12-WTP-0395

TRANSMITTAL OF DEFENSE NUCLEAR FACILITIES SAFETY BOARD (DNFSB)  
RECOMMENDATION 2010-2 IMPLEMENTATION PLAN (IP) DELIVERABLE 5.5.3.1

**Subject:** ONE SYSTEM TECHNICAL TEAM RESPONSE TO REVIEW OF ONE SYSTEM INITIAL GAP ANALYSIS BETWEEN WASTE TREATMENT PLANT WASTE ACCEPTANCE CRITERIA AND TANK FARM SAMPLING AND TRANSFER CAPABILITY (ERT-21)

<b>LSIMS ERT DOCUMENT REVIEW RECORD</b>			<b>REVIEW NUMBER:</b>	ERT-21 Initial Gap Analysis
			<b>DOCUMENT NUMBER:</b>	RPP-RPT-53343 24590-WTP-RPT-MGT-12-022, Rev. Draft
			<b>DOCUMENT TITLE:</b>	One System Initial Gap Analysis Between Waste Treatment Plant Waste Acceptance Criteria and Tank Farm Sampling and Transfer Capability, 2010-2 Implementation Plan Commitment 5.5.3.1
			You may want to be more explicit in the figure that the bias being reported is a RMSD across several batches.	
7	LMP	E	Page 43: Is statement 3 (“within 10%”) fair given that there’s a bias of 20% or more? Is Figure 4-7 just the error bars on Figure 4-6? Don’t connect data within these figures with lines, especially if the components are simply in alphabetical order.	Deleted Figure 4-6 (% relative difference results not used in the propagating sampling uncertainti

**Figure 2-1. Elements of Feed Uncertainties.**

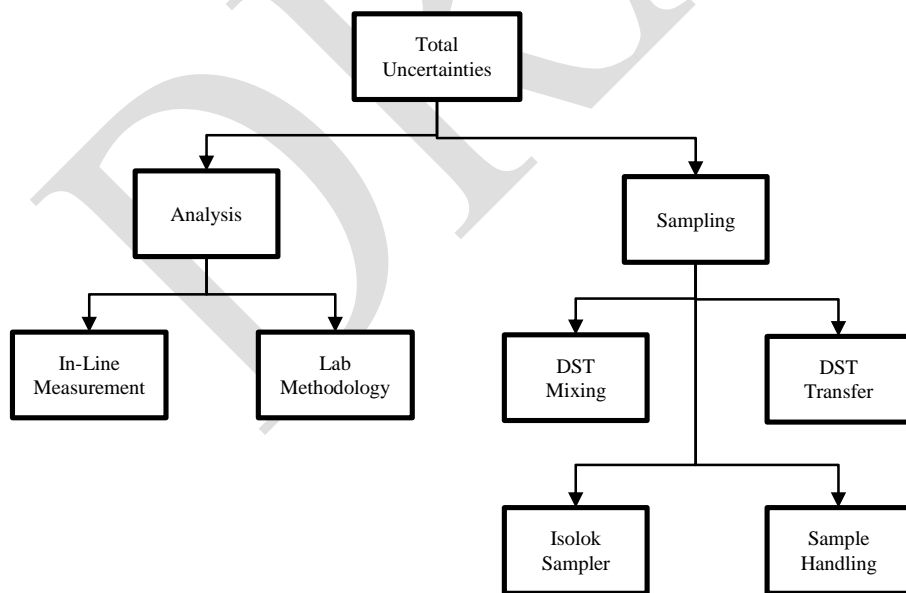
26	EKH	E	Page 19, Section 2.1, fourth paragraph, second sentence: Recommend “These RSDs are <b>determined</b> by Subject Matter Experts ...”.	Accept.
27	EKH	E	Page 19, Figure 2-1: This is a little confusing. I would have expected two branches coming off total uncertainties, DST Mixing, and DST transfer; one being In-line measurements and the other being Isolok sampler, sample handling, and lab methodology.	DST mixing and DST transfer uncertainties are binned under Sampling to account for their potential impact (spatial and temporal respectively) on the pre-transfer samples. Everything is relative to the waste acceptance decision so focus is on the samples and analysis.
28	EKH	M	<b>Page 19, Section 2.1, fifth paragraph, last sentence: This validated output uses an average solids density of 3.0 g/cm<sup>3</sup>. This is above the 2.9 g/cm<sup>3</sup> wac limit and definitely way above the 2.18 g/cm<sup>3</sup> average limit specified in Table 3-2. This would indicate you’ve got problems off the bat! Address this difference.</b>	Agree. As stated in Table 3-2, this parameter (2.18 g/ml) is not a “WAC” limit yet (i.e., not in ICD-19). However the apparent disconnect between the TOC planning basis (HTWOS) and the WTP design basis could have potential production impact. This is identified as an “Open Item” to reconcile the disconnect.

**Figure 4-2. Total Solids Mass Trend**  
(Relative Standard Deviation for the 5 Batch Transfers).

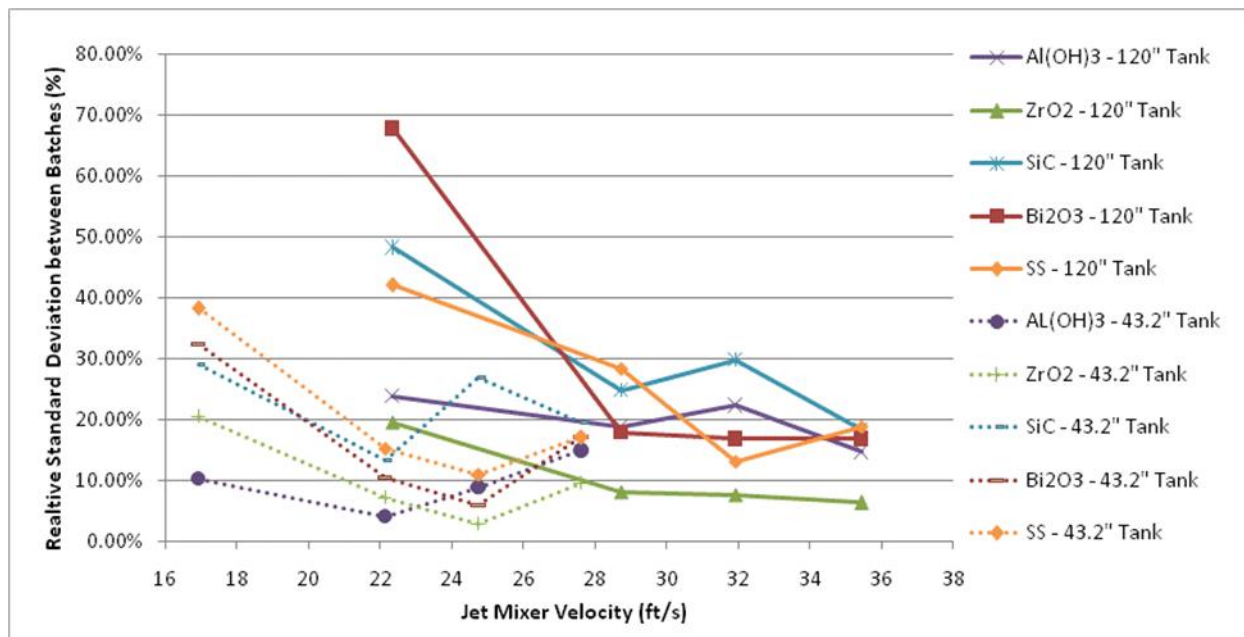
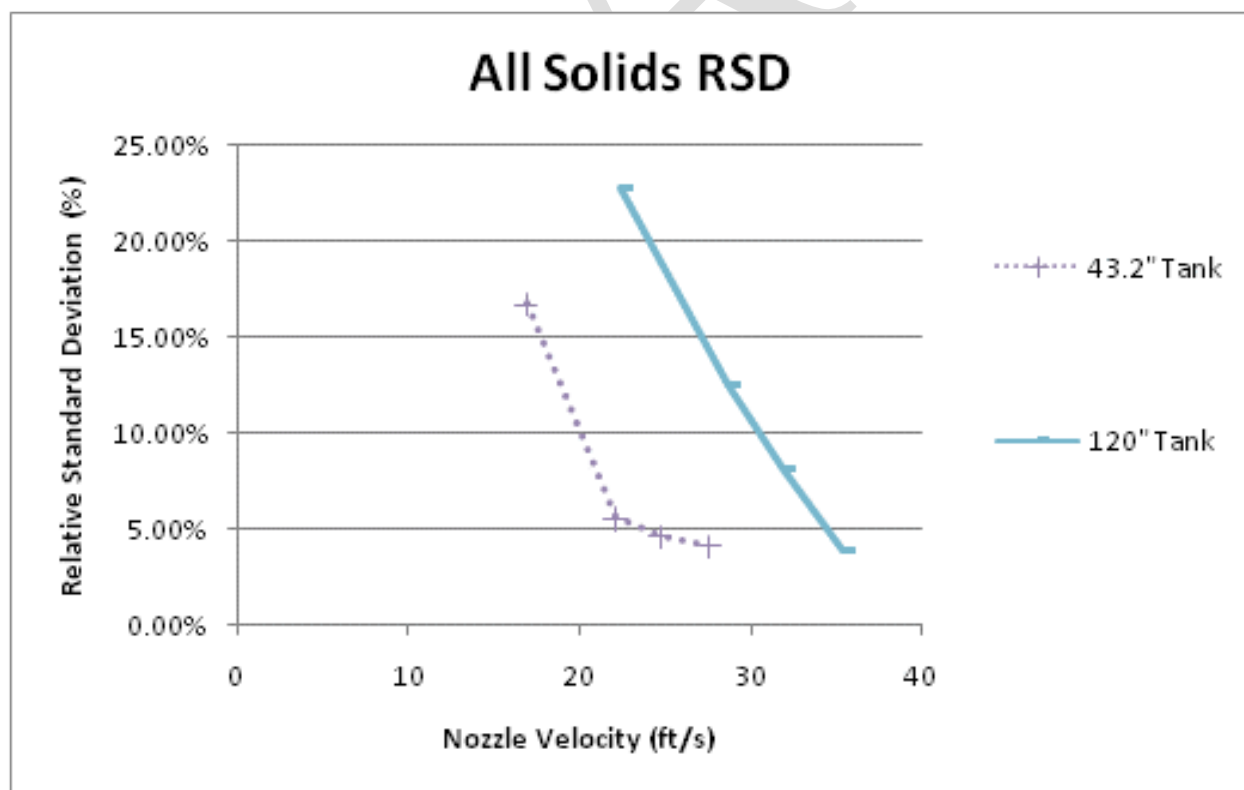
143	RRH		Page 36, Section 4.1.2: It is mentioned that SSMD program has 4 phases with 2 phases already completed. I assume the program described in RPP-PLAN-53193 (ERT-20) is the 3 <sup>rd</sup> phase.	Most likely.
144	RRH		Figure 4-2 shows effect of nozzle velocity on RSD as expected--RSD decreases as nozzle velocity increases on both scales. However results plotted in Figures 4-1 and 4-3 are confusing. I suggest replotting these data as follows: <ul style="list-style-type: none"> <li>Chemicals on X-axis should be in the increasing order of settling velocity.</li> </ul>	These figures are copied from the SSMD test report and can't be replotted. Replaced original Figure 4-2 that better depicts the relationship between RSD and mixer jet velocity (now Figure 4-1). Deleted the original Figure 4-1.

**Figure 4-6. Transfer System Particle Transport Limit. Representative Bounding Liquid (1.37 g/mL, 14 cP), Limiting Pipeline Length and Pressure, 0.99 miles, 400 psig.<sup>8</sup>**

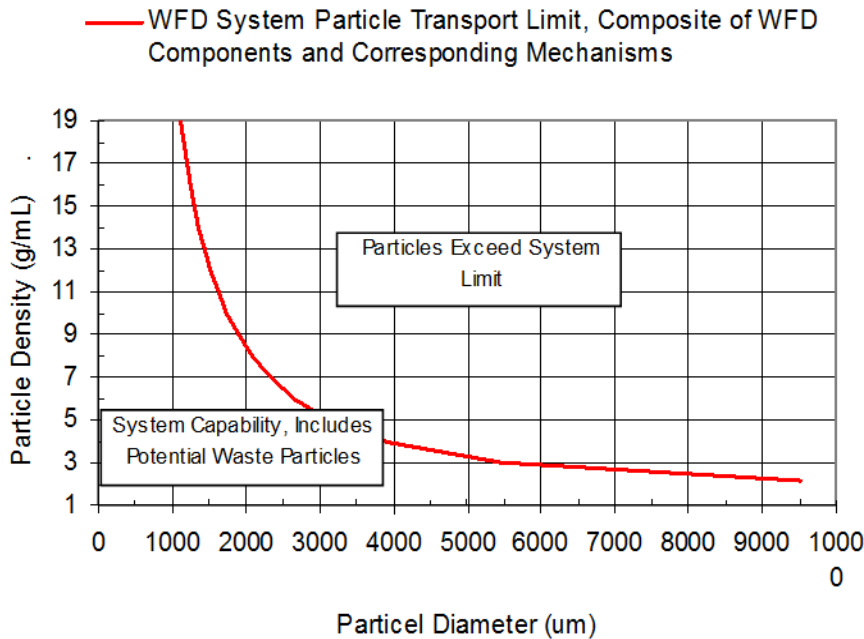
9	LMP	M	<b>Figure 4-8 is inadequately described, i.e., is this just representing the capability of the transfer lines themselves or the pump suction, etc.?</b>	Added description for Figure 4-8 from the source report.
10	LMP	E	Red solid line on Figure 6-11 appears to be incorrect unless the number of samples is always 2 no matter what.	Number of samples is 2 given the analytical and sampling RSD at the specified Confidence Level (90%). See sensitivity results. This one is not sensitive to sampling/analytical uncertainties due to concentrations far below the action limit.
11	LMP	E	I find the discussion of average bulk solids density somewhat confusing. “A majority of the primary particles in the aluminum phases exceed the 2.18 g/mL limit,” but it isn’t clear what fraction of the bulk solids are aluminum phases or how big those majorities are.	Noted. Distribution of densities of primary particles is not given in the source report, other than a histogram of frequency of observation. Added a few qualifier to the discussion but also highlighted an alignment issue between the Tank Farm planning basis (HTWOS) and the WTP design basis (i.e., 3 g/mL vs 2.18 g/mL).

75	EKH	O/E	Page 46, Figure 4-8, Title: Not sure how important the length or pressure is, unless the method of calculation determines the velocity given these limitations and particle/density. Again, not clear.	Accept. Included additional description of the graph from the source report. The evaluation considered the limitation of velocity and pressure drop in the transfer line (see report for detailed discussion).
76	EKH	O/E	Page 47, Section 4.2, second paragraph, third sentence, "... largely liquid phase constituents ...": This is true if the liquids do not contain floating liquids are the liquids are immiscible.	Accept. Added "... (assuming the liquid constituents are miscible) ..." as a qualifier.
77	EKH	O/E	Page 48, Section 4.2.1, second paragraph, first sentence, "... sampling ...": There can also be systematic errors, e.g., the sampler is also dependent on what feed is provided and the environment from which it samples. Change the environmental conditions you can change its performance!	Accept. Changed to "... two dominant sources of uncertainties in the <i>waste acceptance decision</i> are traceable to sampling and analytical ...".

149	RRH		Figure 4-8: Use of a combination of particle dia. and particle density may not be sufficient to characterize system capability and limit. Estimated settling velocity and critical velocity should also be included.	Noted. Again this is based on the work published in RPP-RPT-51652.
150	RRH		Section 4.2.1.2, Gy's Seven Basic Errors: While these concepts are impressive, they appear to be academic. Ideally robust sampling and analytical protocols should be	Noted. Moved the Gy's discussion to the back in Appendix C.
